FINAL DRAINAGE PLAN SF 22-001

SKYLINE AT LORSON RANCH

**DECEMBER, 2021
REV MARCH 1, 2022**

STORM SEWER LATERAL
STORM LATERAL 'A'
AND POND C4 IMPROVEMENTS

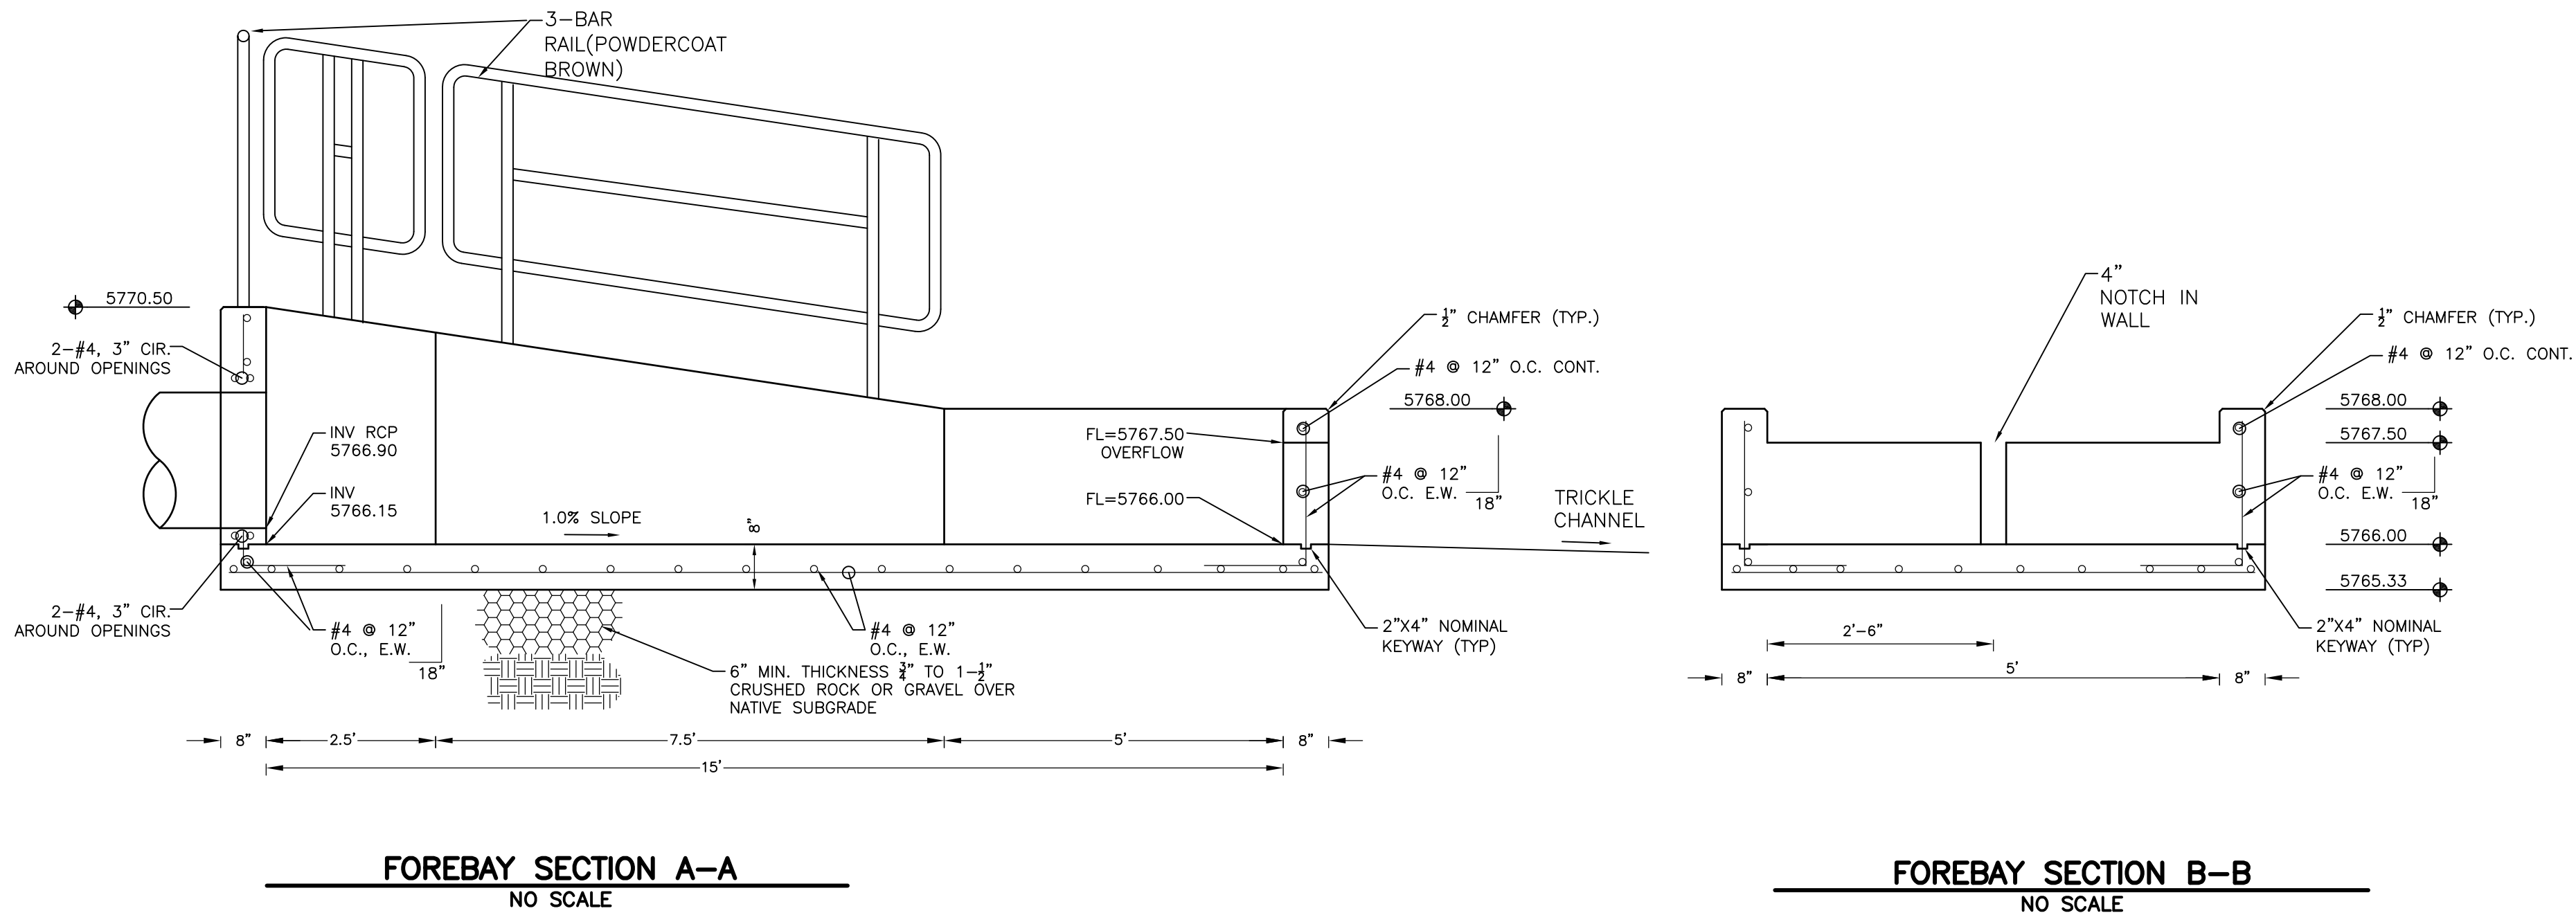
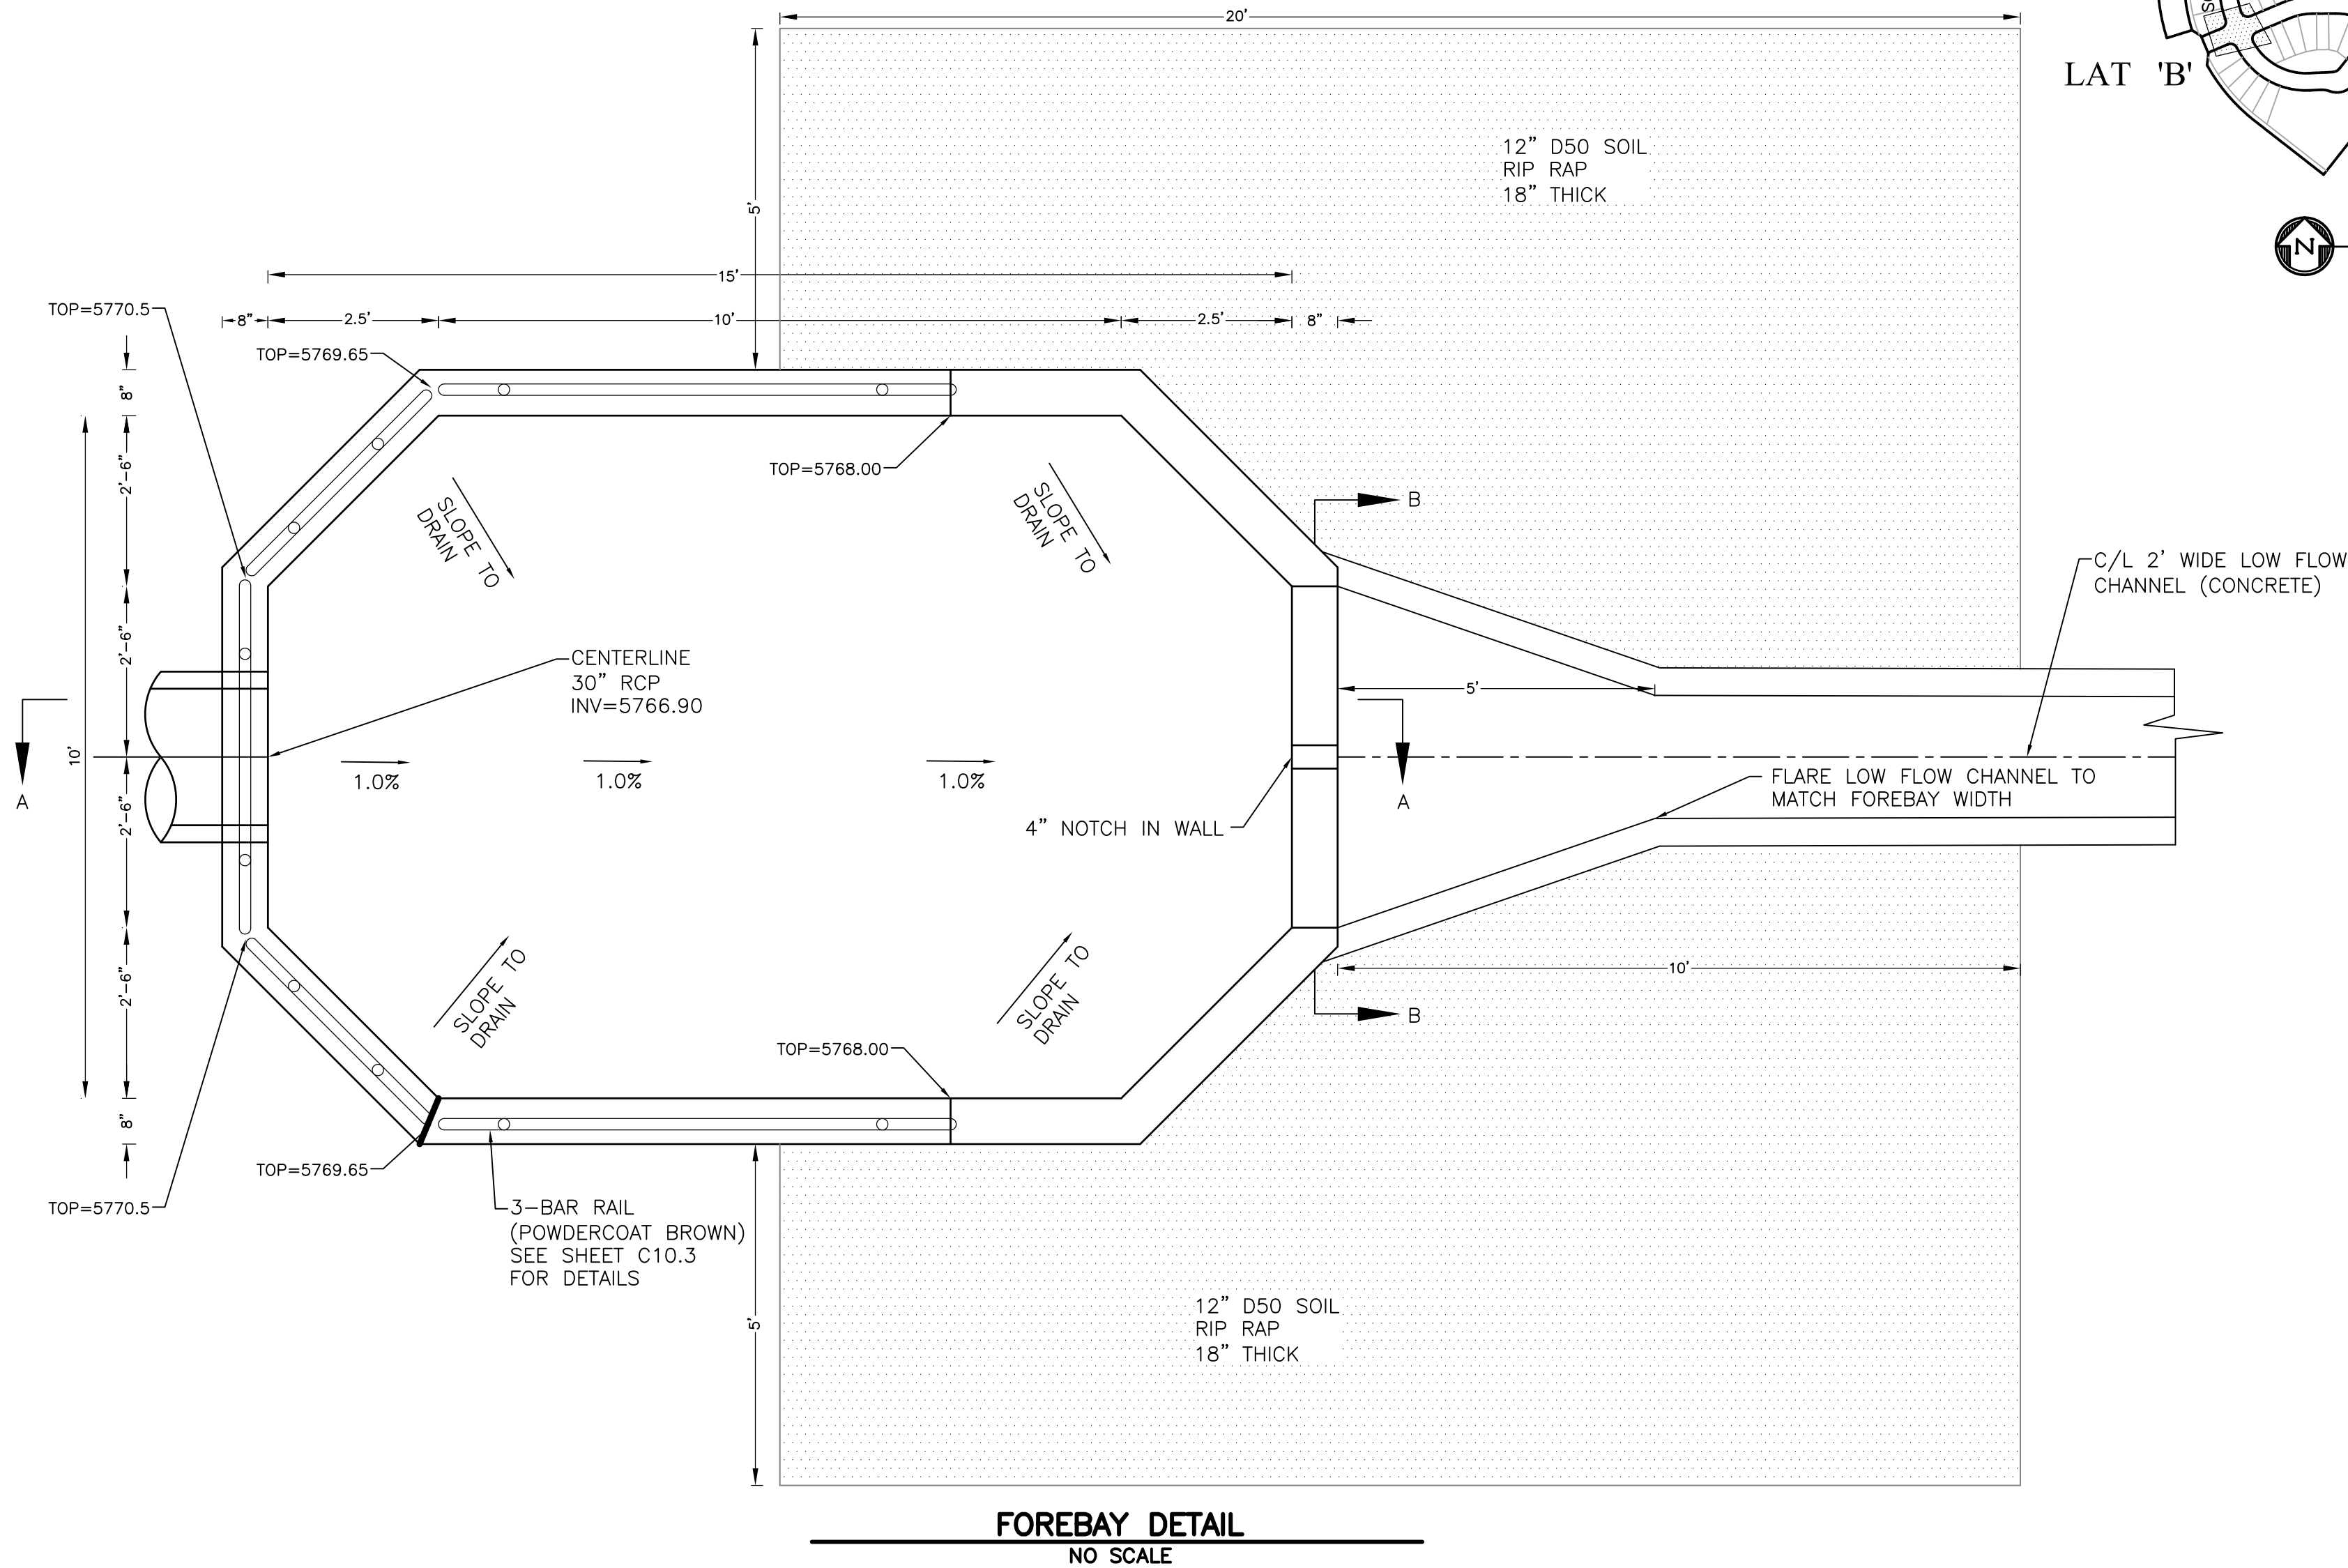
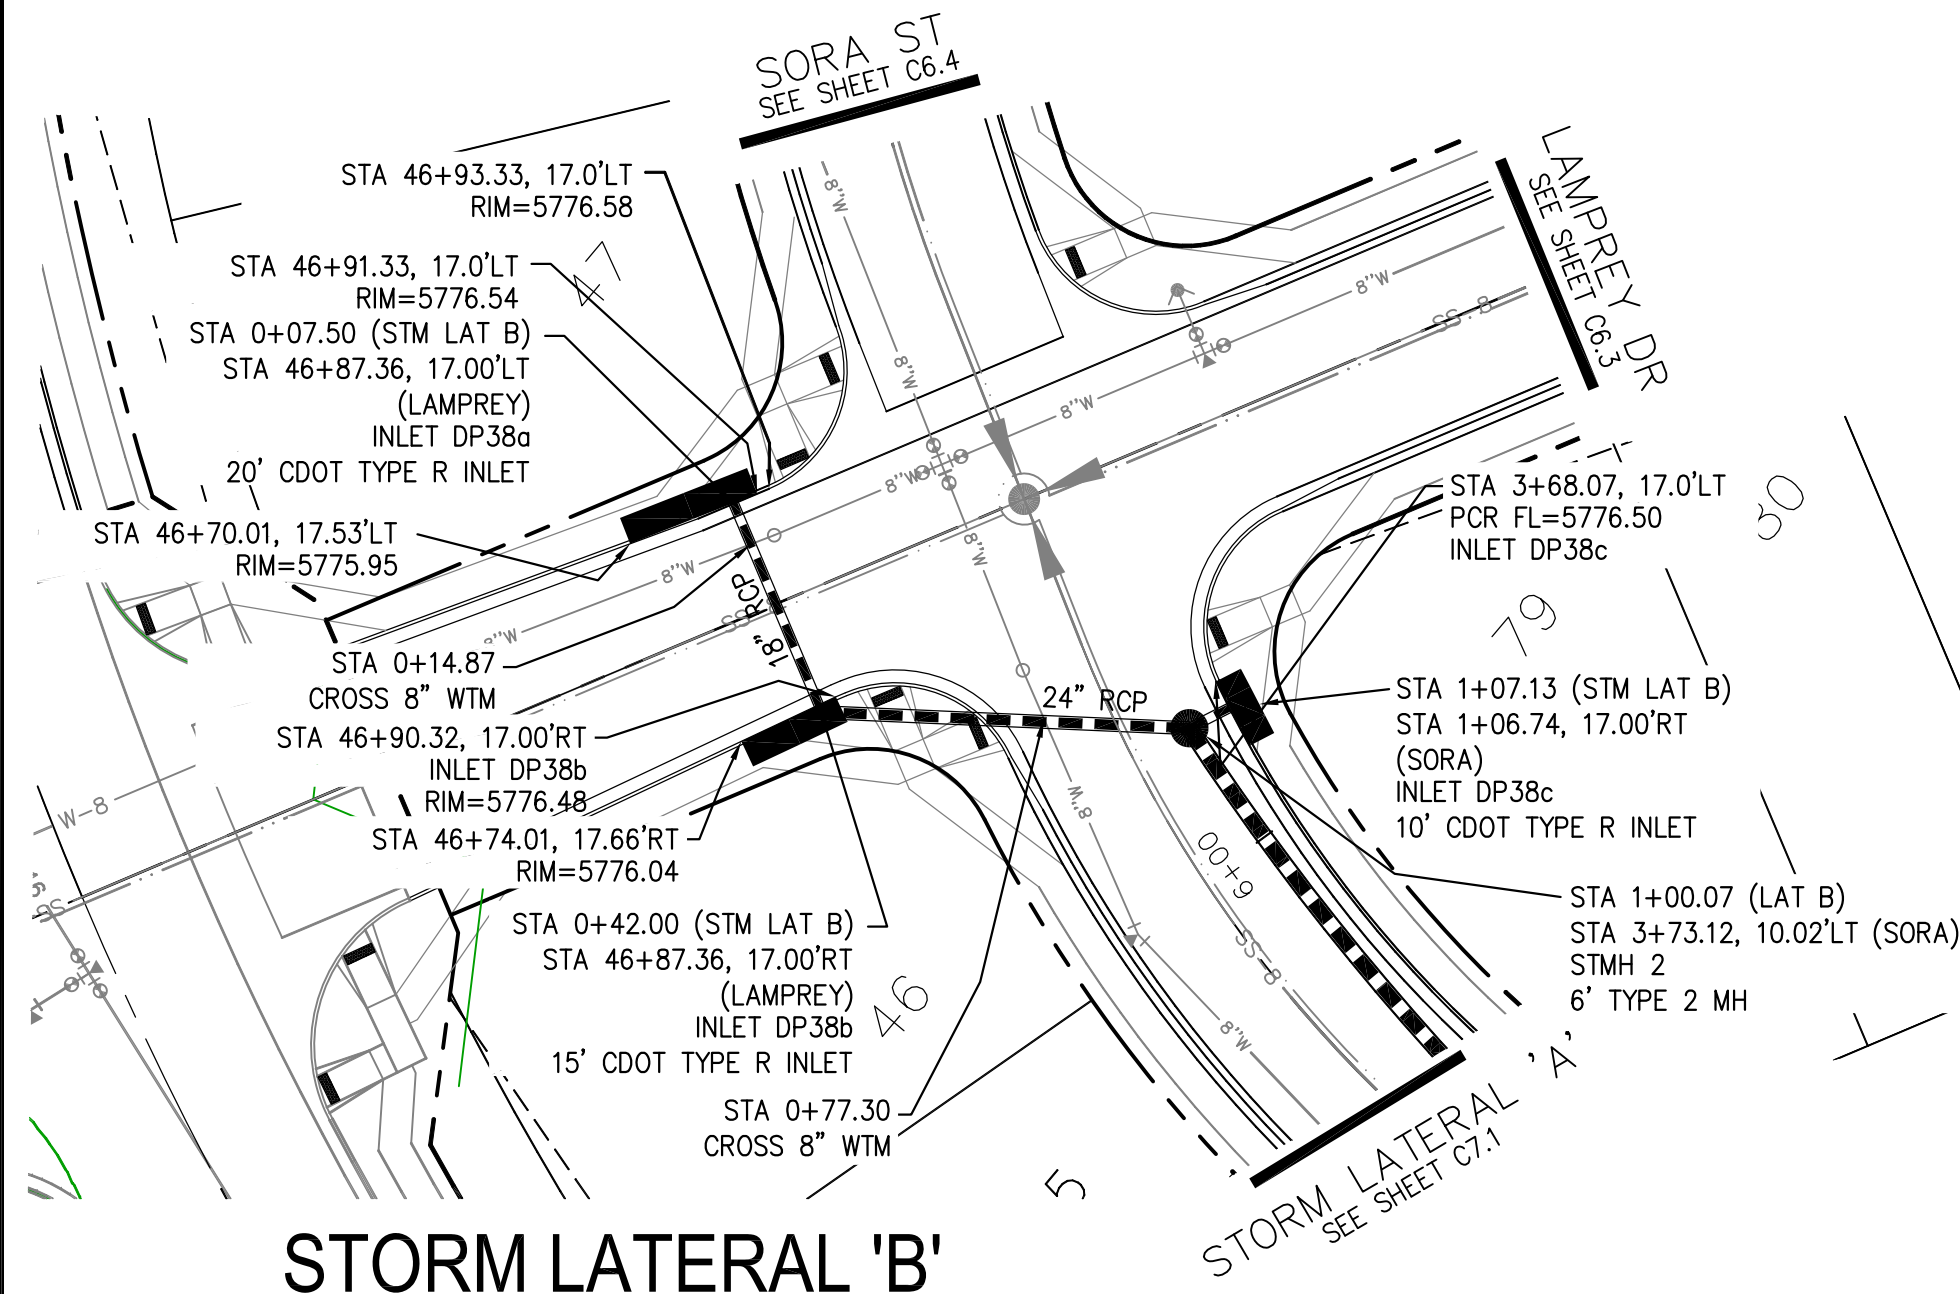
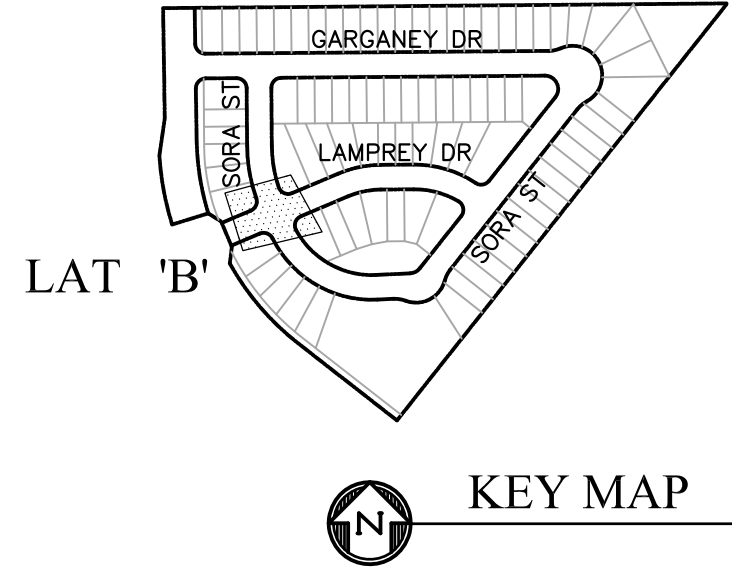
Pipe lengths and inverts do not match storm model data. Please revise accordingly so model and construction drawings match.
